STAFF REPORT
KETCHUM PLANNING AND ZONING COMMISSION
March 5, 2026

The Wood River YMCA is proposing an interior remodel, addition, and exterior improvements within their leased boundary located at 101 Saddle Road within the Tourist District. (See Fig.1). A Pre-Application Design Review is required for the 26,464sf addition which includes a new main entrance lobby, teen center, and a field house with an upper-level running track proposed to be added to the north end of the facility. Exterior improvements are also proposed requiring design review; including a heated sidewalk, landscaped areas adjacent to addition, removal of existing main entrance stairs, and parking and fire/emergency access reconfiguration. See Attachment A.III Pre-Design Review Drawings.

**STAFF REPORT
KETCHUM PLANNING AND ZONING COMMISSION
MARCH 5, 2026 MEETING**

Figure 2 3D Perspective of Addition

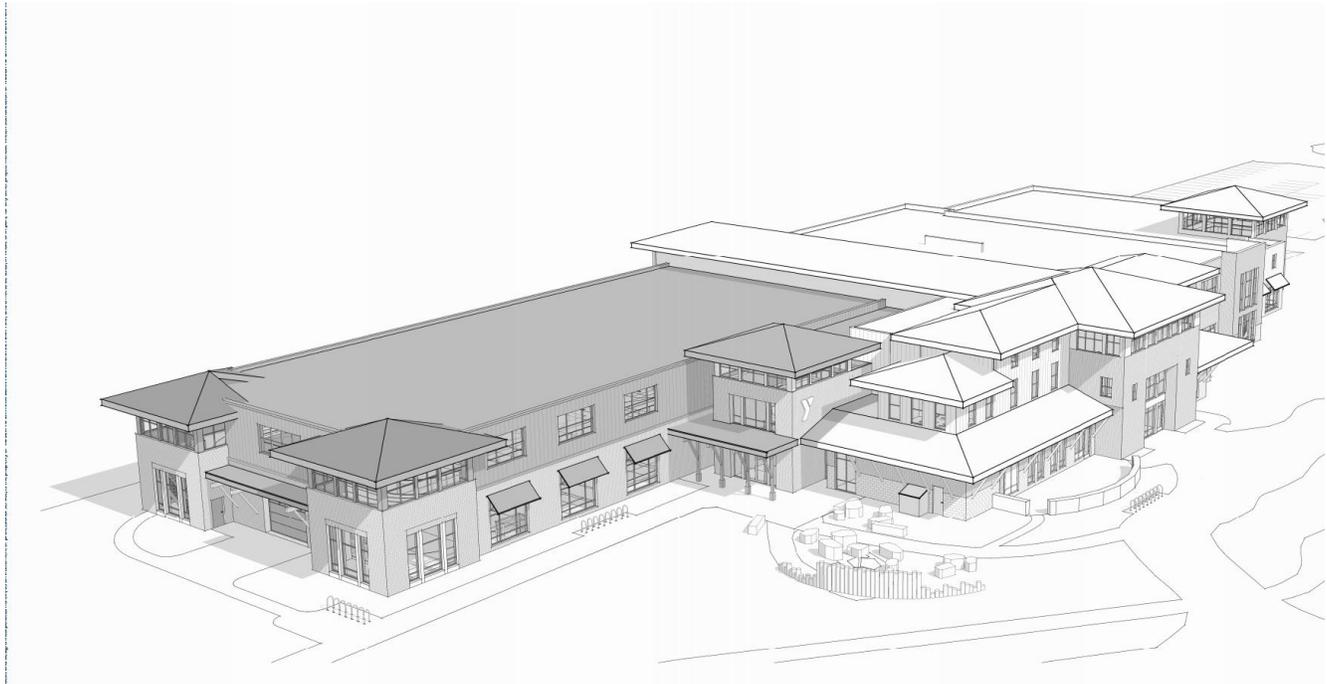
The proposed addition (See gray portion of Fig 2 below) continues the existing character as seen in the use of the same materials and color palettes. The continuation of the flat roof and three sloped roofed areas add interest within the addition and mirror the roof design existing throughout the structure.

Figure 3 Western Elevation

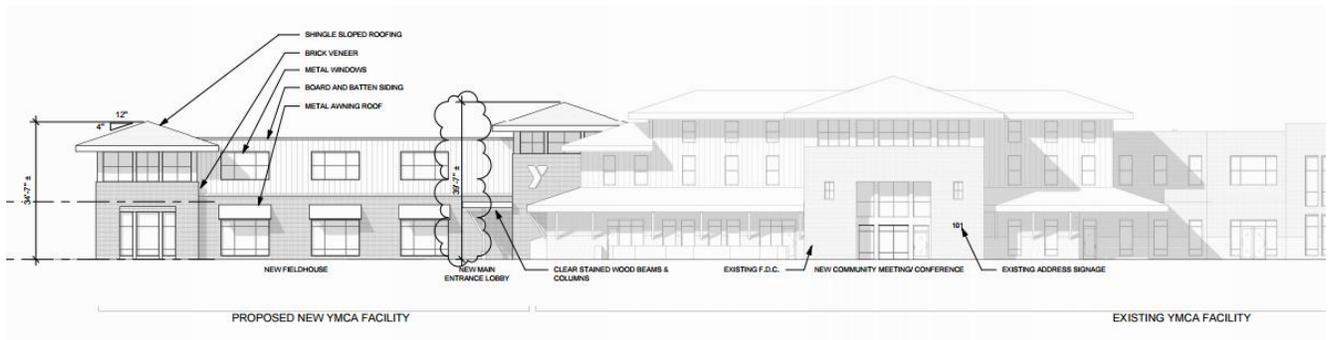
The western elevation (Fig 3) of the addition which faces Warm Spring Road has continued the design of predominate brick veneer with the hardboard on the second level. The bulk and mass is broken up by mirroring pedestrian scale awnings seen on the southern end of the building, inclusion of a variety of roof lines, and the large windows with panes to break up the flatness of the large walls. (See Sheet A.4 Building Elevations & Materials)

Figure 5: Site Plan(Sheet A1) highlighting areas to be landscaped

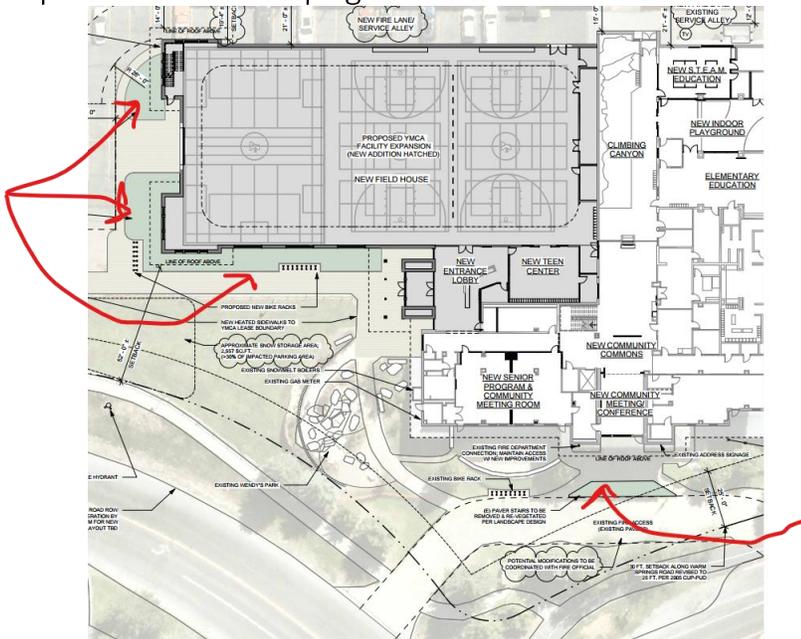
The applicant is proposing to move the existing front entrance to the northern addition creating a new front lobby. The proposal on site plan Sheet A.1 describes landscaping features to be installed to buffer the northeast and west portions of the new structure with the surrounding hardscape . New bike racks are also shown. The existing “Wendy’s Garden” will remain and is surrounded currently by permeable landscaping that also serves as 2,557sf of snow storage area. More specific

details will be required at time of design review regarding anticipated plant types and location as required in the landscaping section I: 1-4. of the evaluation standards.

COPYRIGHT © 2025
DRAWING
BUILDING ELEVATIONS & MATERIALS
DWG #

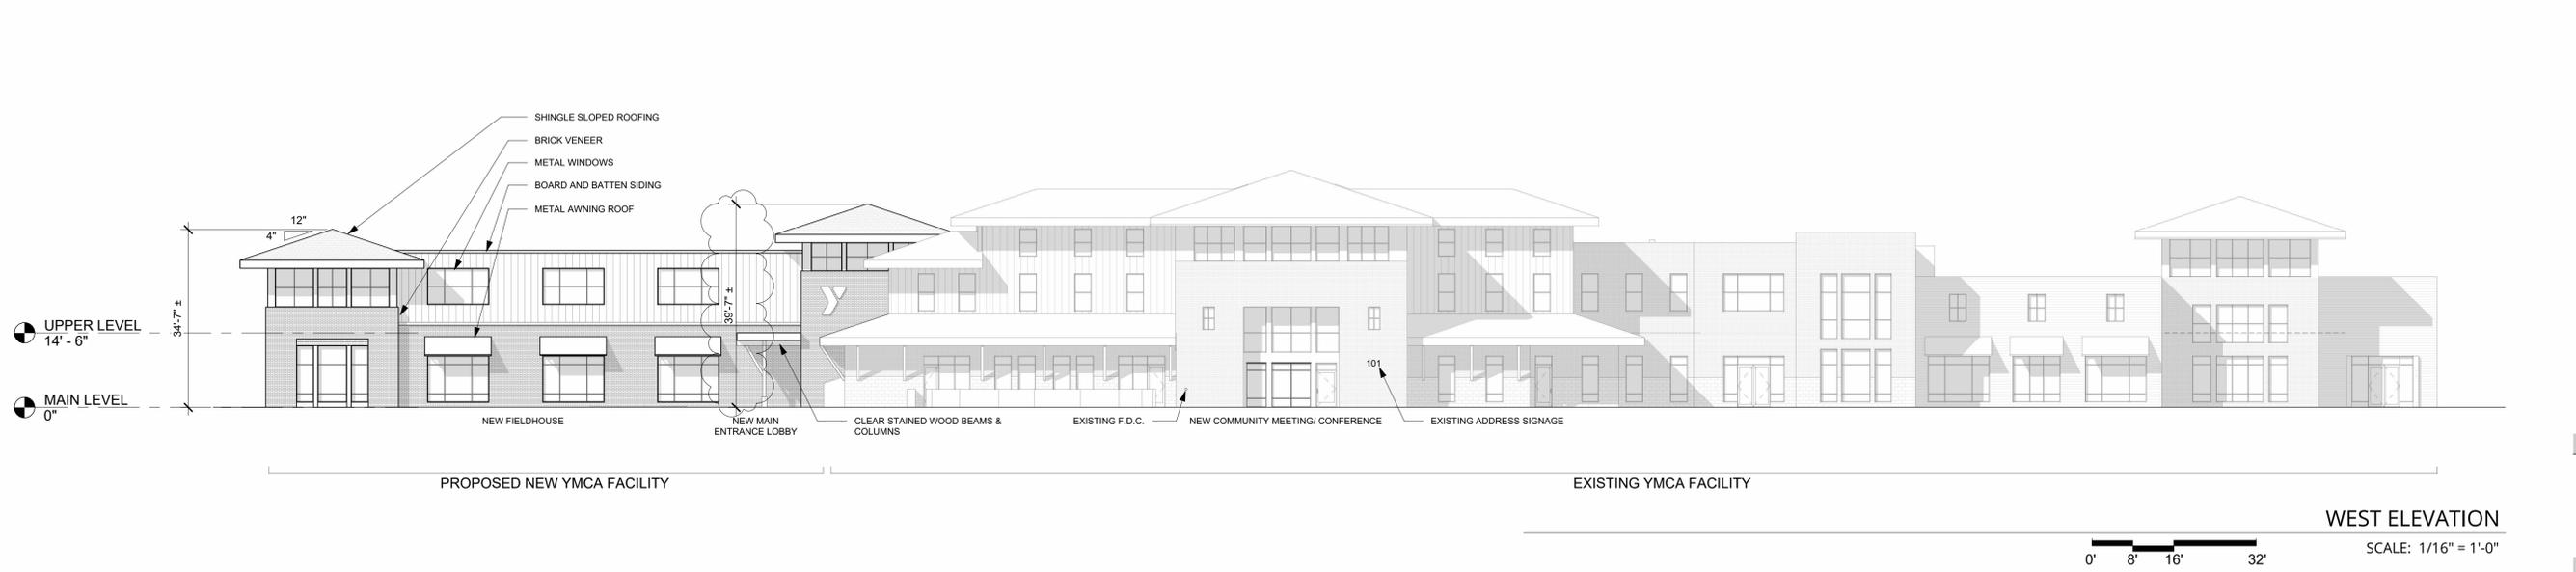
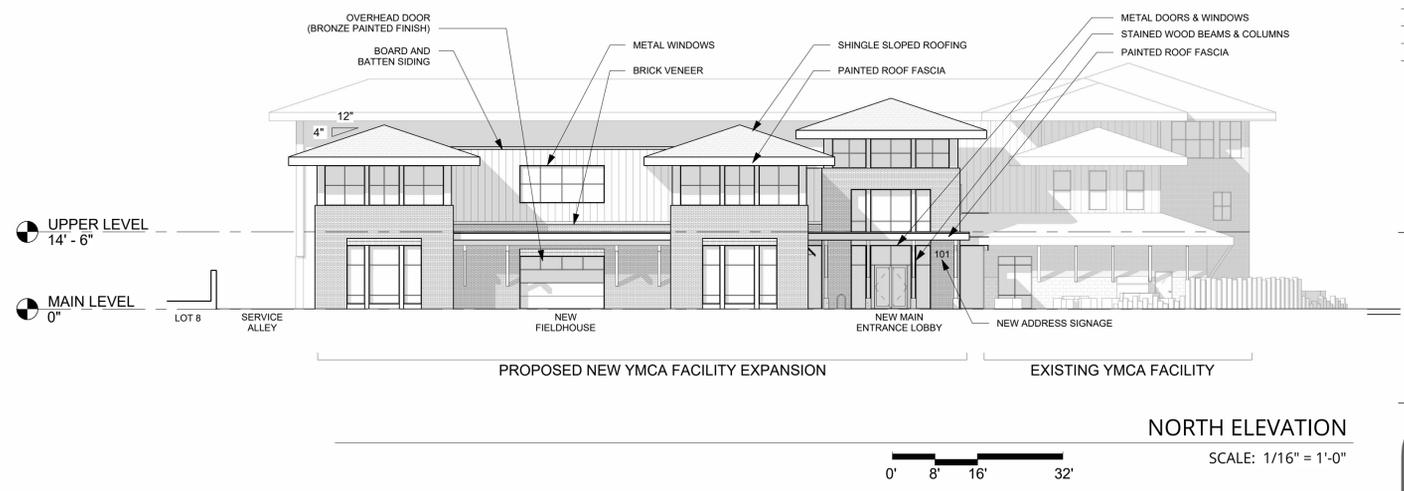
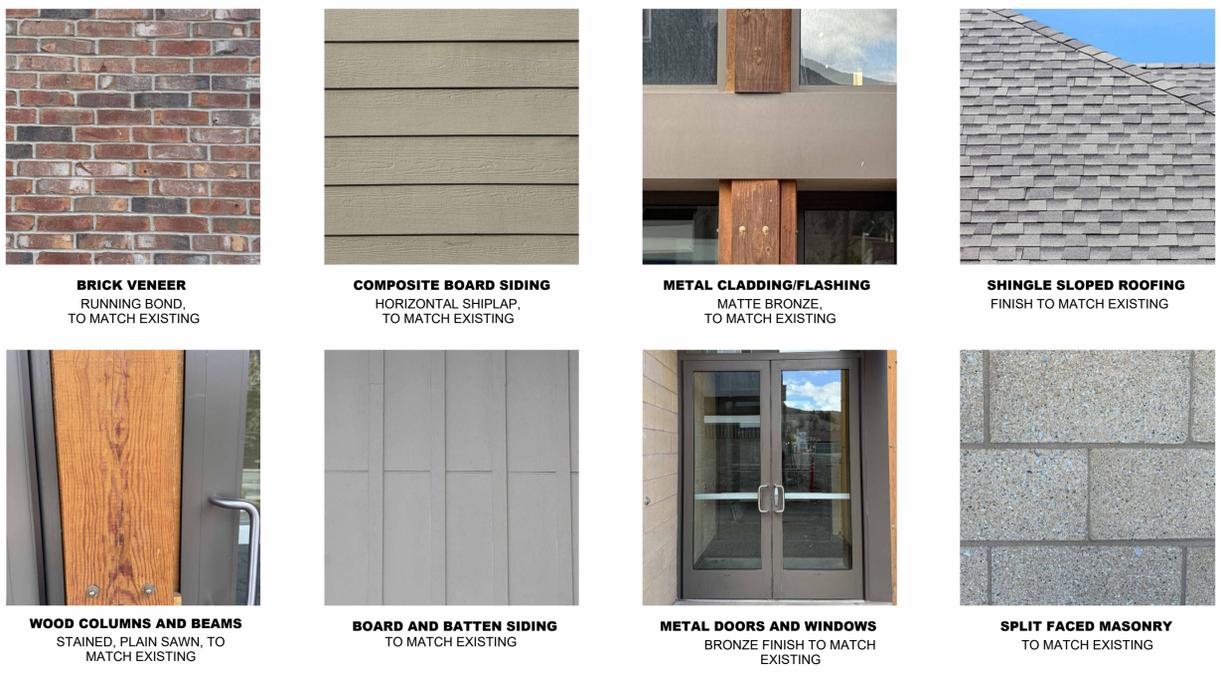
1) KMC §17.96.060.E. *Compatibility of design* states; 1. *The project's materials, colors and signing shall be complementary with the townscape, surrounding neighborhoods and adjoining structures.* The materials proposed on Sheet A.4(See Image below) match the existing structural materials including the shingled roof, brick, horizontal board siding, metal finishes, wood columns and beams, masonry, board and batten, and the existing metal and glass doors. The colors of the proposed materials are designed to match the existing building therefore the addition would appear to be fully integrated into the existing architectural palate and materials. Refer to Sheet A4: Building Elevation and Materials for Specific locations of building materials.

SHEET TITLE
 Variance Site Diagrams

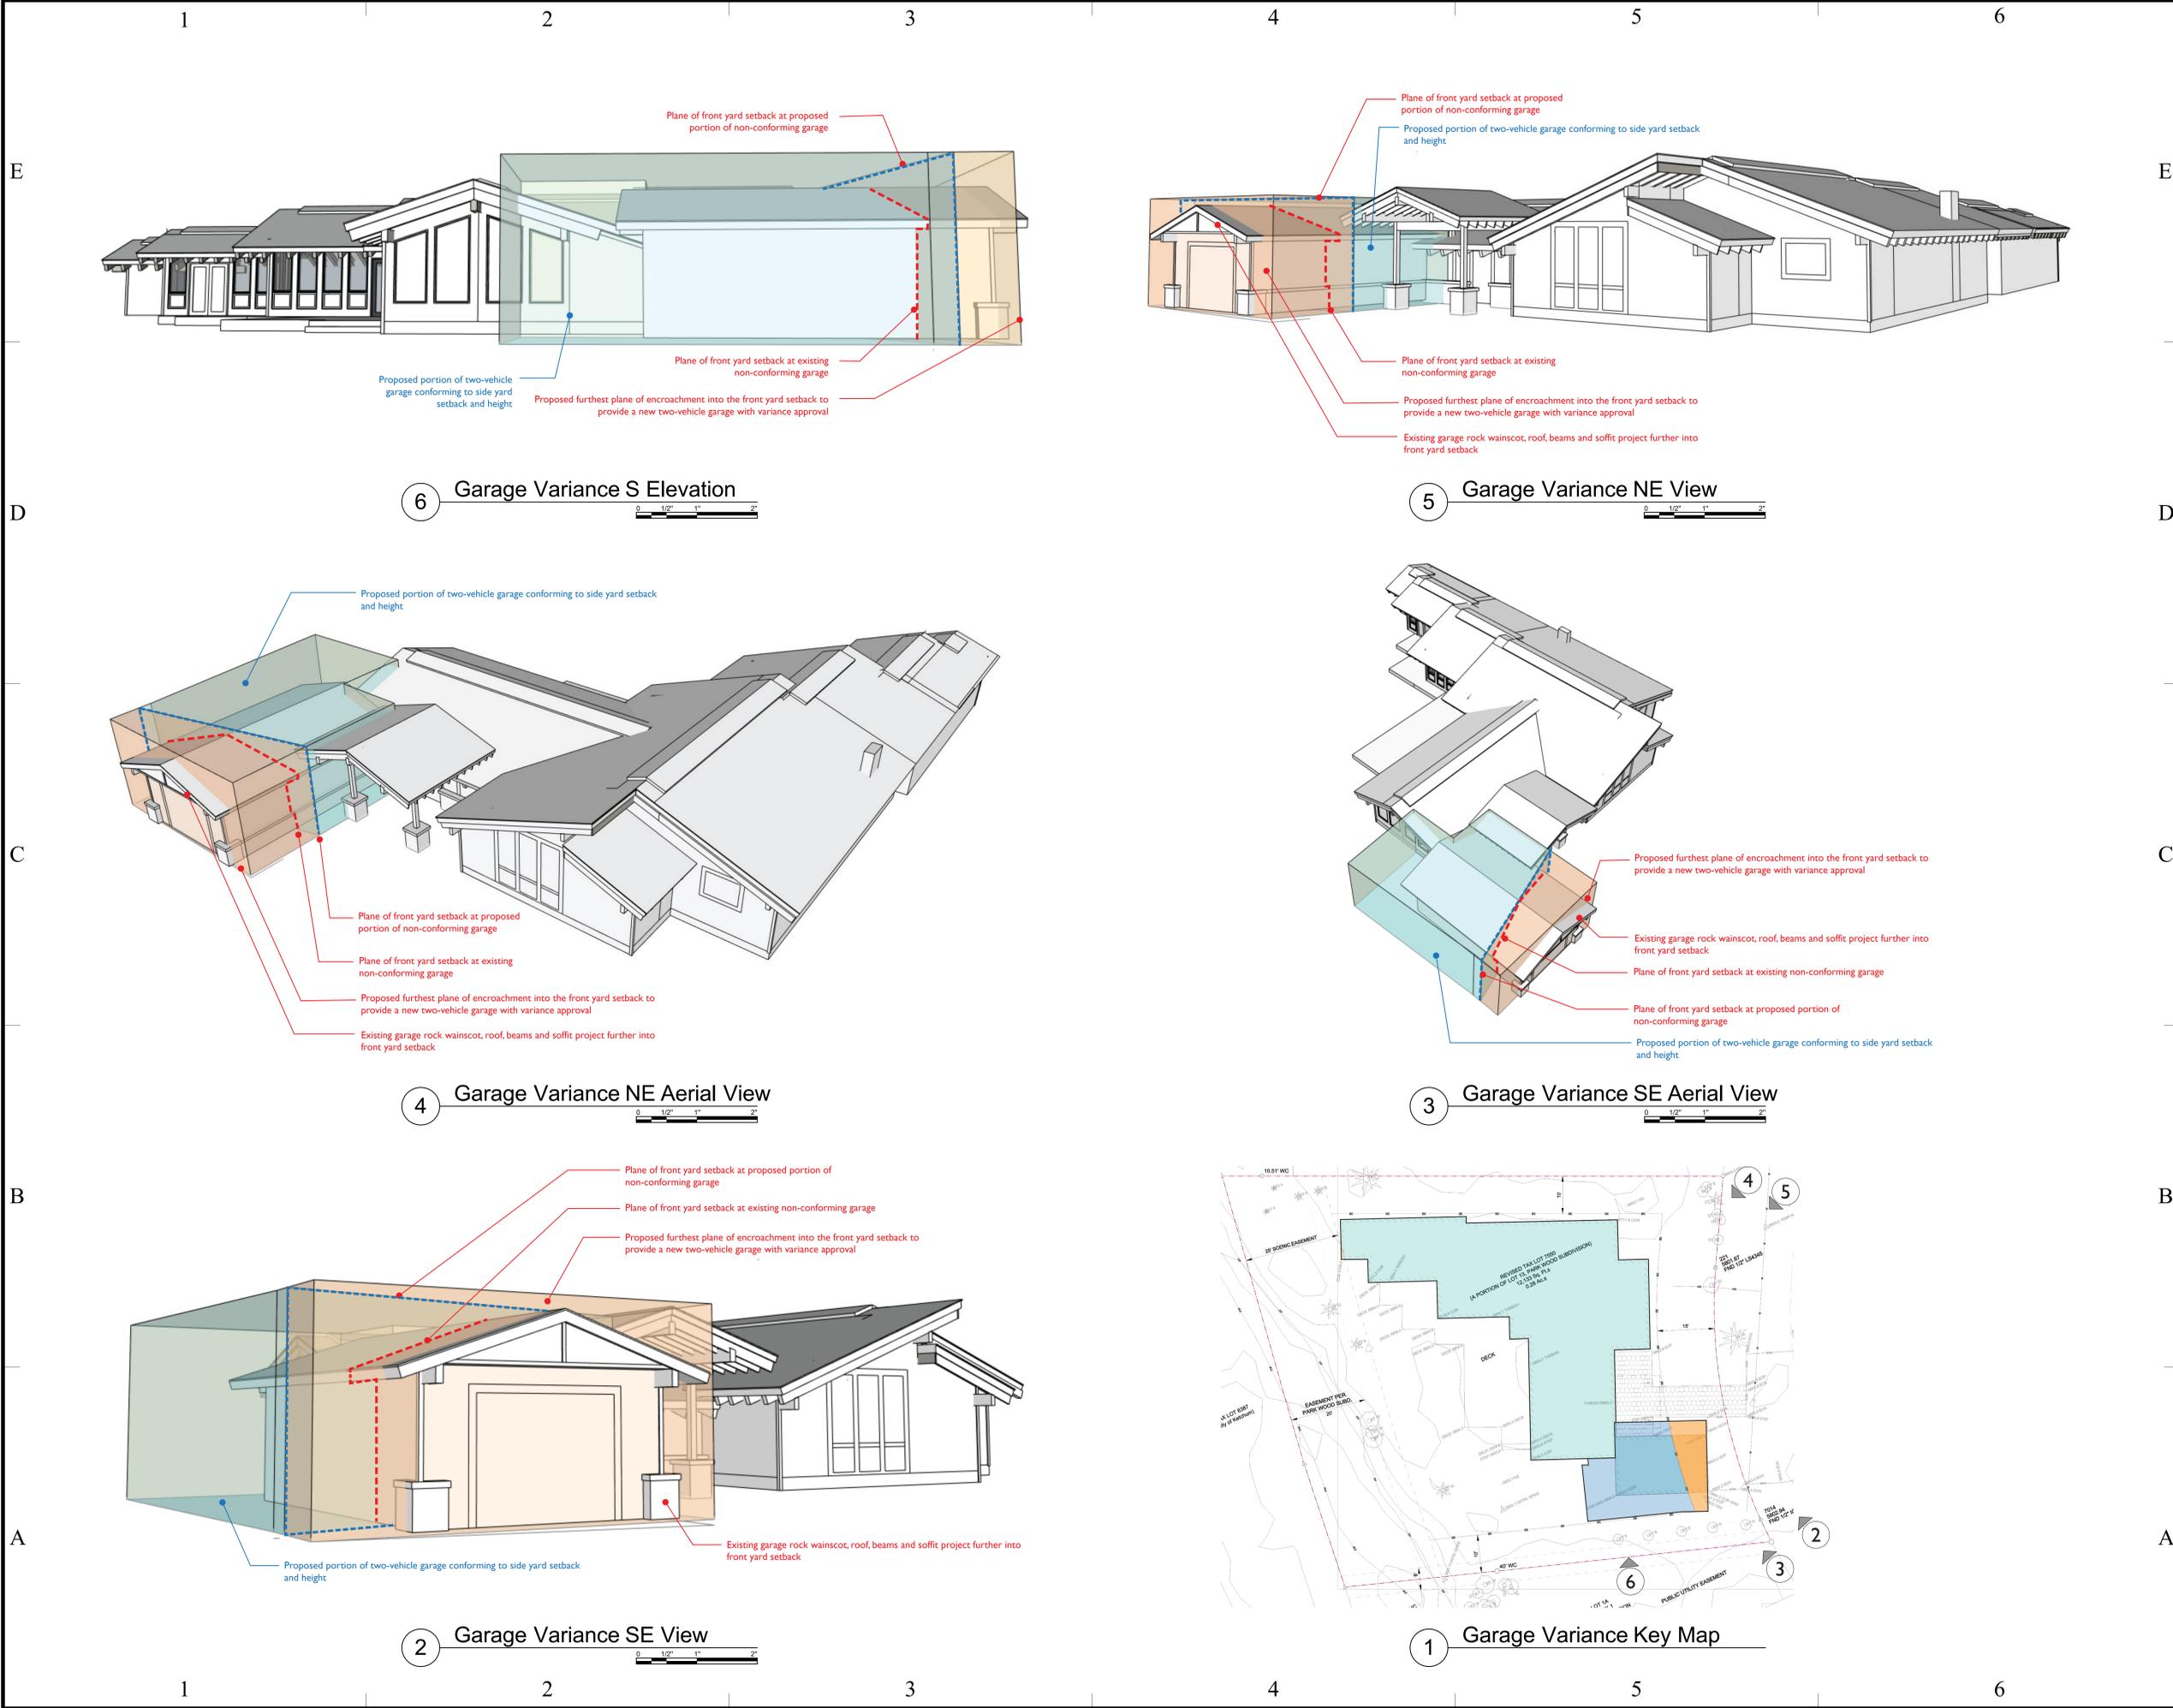
Staff Analysis: As outlined on Sheet G-002 in the application materials included as Attachment A, the applicant team developed several alternative studies to provide a two-vehicle garage and determined that the proposed design of the two-vehicle garage is the least impactful to the existing structure and surrounding neighborhood of options A-E they explored. While the proposed garage would increase the degree of nonconformity in regard to the front setback, it would also decrease the degree of nonconformity as it would also bring the residence into conformance with off-street parking requirements.
